AG-SB-2017-02-C-EN – Calidus compressor fuse

Category C

28.02.2017

Fig. 1: 10A Fuse Compressor

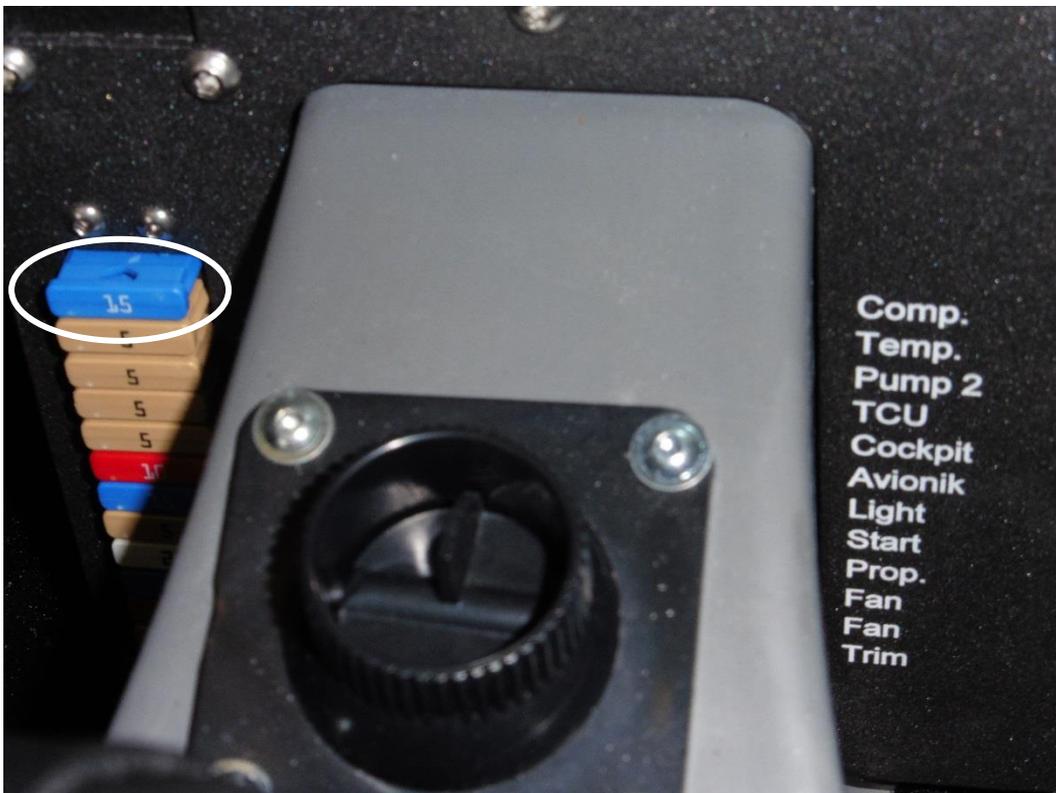
Production quality control checks have determined that variability in the current required to start the compressor could be in excess of the circuit 10A fuse, causing it to blow. Whilst there have been no recorded fuse blows in service, this bulletin highlights this potential and provides a preventative service fix.

- Replacing the 10A fuse for the compressor with a 15A fuse.

- 1 Remove the 10A fuse for the compressor from the slot.
- 2 Insert the 15A fuse into the compressor slot
